DATE: May 31, 2024

TO: Planning Commission

FROM: Comprehensive and Neighborhood Planning Committee

SUBJECT: River Balcony Master Plan Proposed Addendum – Basis of Design Report

RIVER BALCONY SCHEMATIC PLAN

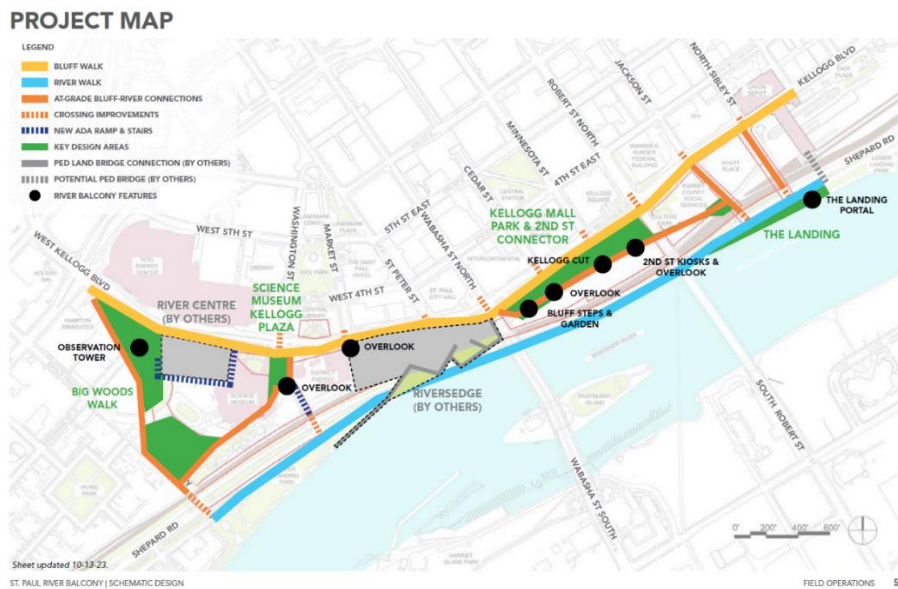
The basis of design report uses Kellogg Mall Park, one of the largest city-owned parcels along the project area and enhances the central core of the River Balcony by adding the “Kellogg Cut” to open views and provide access to 2nd street which is converted to a pedestrian corridor.

Public engagement strongly supported measures to improve at grade crossings along Shepard Road. The basis of design report proposes exploring traffic calming and lane reductions to improve the pedestrian experience, access, and connectivity.

The basis of design report embraces Lambert’s Landing as the port of entry to Saint Paul by recommending a welcome center, riverfront seating, and retail/cafe space to create a better pedestrian experience along the river.

Eight overlooks are proposed to draw people from downtown to the river bluff and to preserve historic views identified in the master plan.

OVERALL SITE PLAN

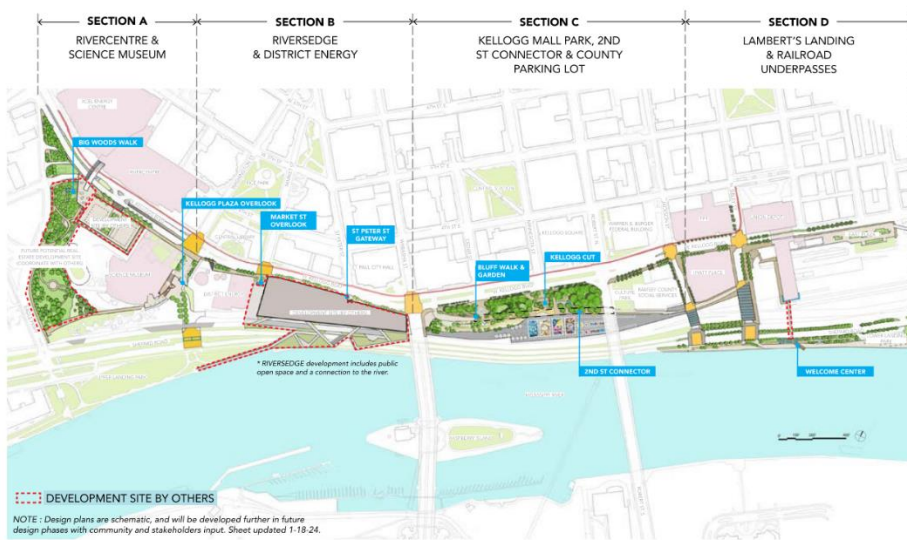
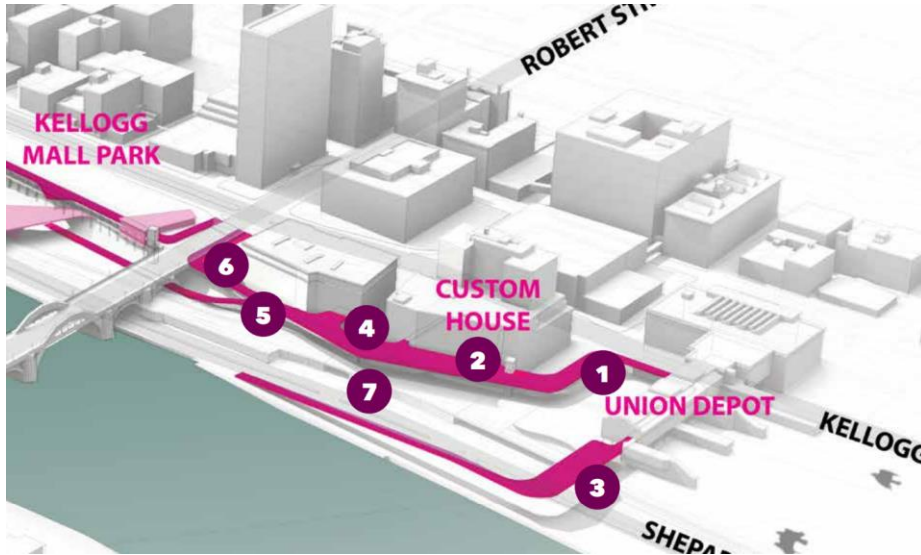
1. Balcony at Union Depot: Union Depot is the east portal into the River Balcony experience. The Balcony will bring people and activity to the 25,000 square feet of available retail in Union Depot.

2. Balcony at Custom House: As the first section of the River Balcony likely to be built, the design has the dual responsibility to establish the overall character of the Balcony going forward, as well as respond to the Mississippi River and the context of this historic part of the city. At Custom House, the design and programming of the River Balcony will play a critical role in activating commercial space on the second floor of the Custom House annex.

3. The curved path over rail and Warner Road: As the eastern-most connection from the River Balcony to the river, the curving, 14-foot wide elevated boardwalk will slope at 5% from Union Depot to the river, Lower Landing Park and the Sam Morgan Trail.

4. Balcony Bridge at Sibley and Jackson Street: Where the River Balcony connects over Sibley and Jackson Streets, it is important to recognize the characteristic of “bridge” as both an historic form and a connection to the river.

Basis of Design Report: The design builds upon the existing infrastructure in lieu of an elevated balcony.

Basis of Design Report: The design builds upon existing infrastructure (2nd Street) in lieu of an elevated balcony. The design calls for converting 2nd street to a pedestrian corridor to continue the street level connection at Jackson Street and the Custom House.

Basis of Design Report: While the curved path is removed from the design because of the expanded design at Lambert’s Landing and Lower Landing, the potential for a pedestrian connection, to be coordinated in the future by others, remains in the design.

Basis of Design Report: The design builds upon existing infrastructure (2nd Street) in lieu of an elevated balcony so there is no bridge proposed over Sibley or Jackson Streets. At grade crossings of Sibley and Jackson are in the basis of design report.

KELLOGG CUT AT MINNESOTA ST

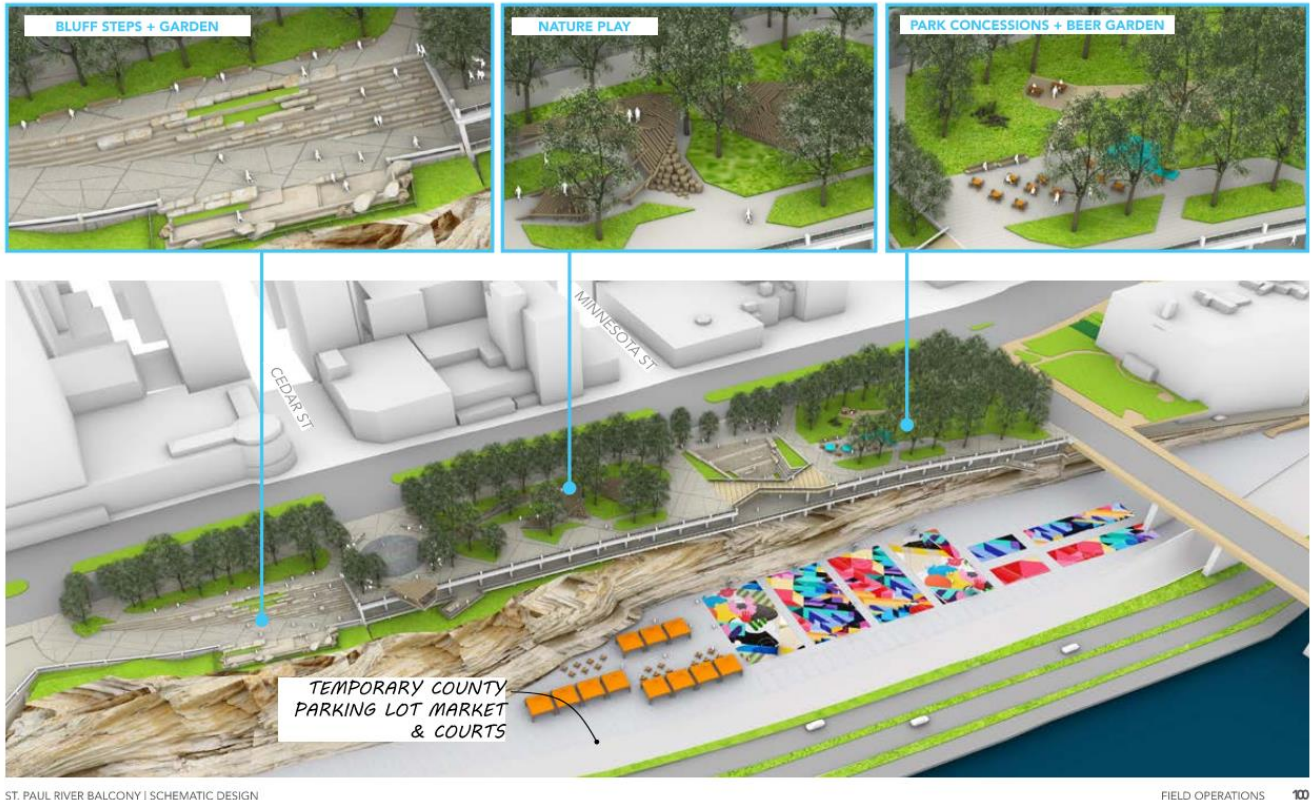
9. Balcony along south edge of Kellogg Mall Park: Kellogg Mall Park will become the central focus for city-wide events and neighborhood activities along the River Balcony. To recapture the Mississippi River as an important aspect of the overall experience of Kellogg Mall Park, the River Balcony railing will be transparent with extended platforms to allow walkers to move beyond the existing bluff and look back to the last remaining segment of natural face of the bluff.

Basis of Design Report: Kellogg Mall Park remains a central focus of the River Balcony including a feature referred to as the Kellogg Cut at the terminus of Minnesota Street. The Kellogg Cut cuts into the park to create an access down to 2nd Street. The design also includes an extended overlook at the terminus of Cedar Street to look back at the natural bluff face.
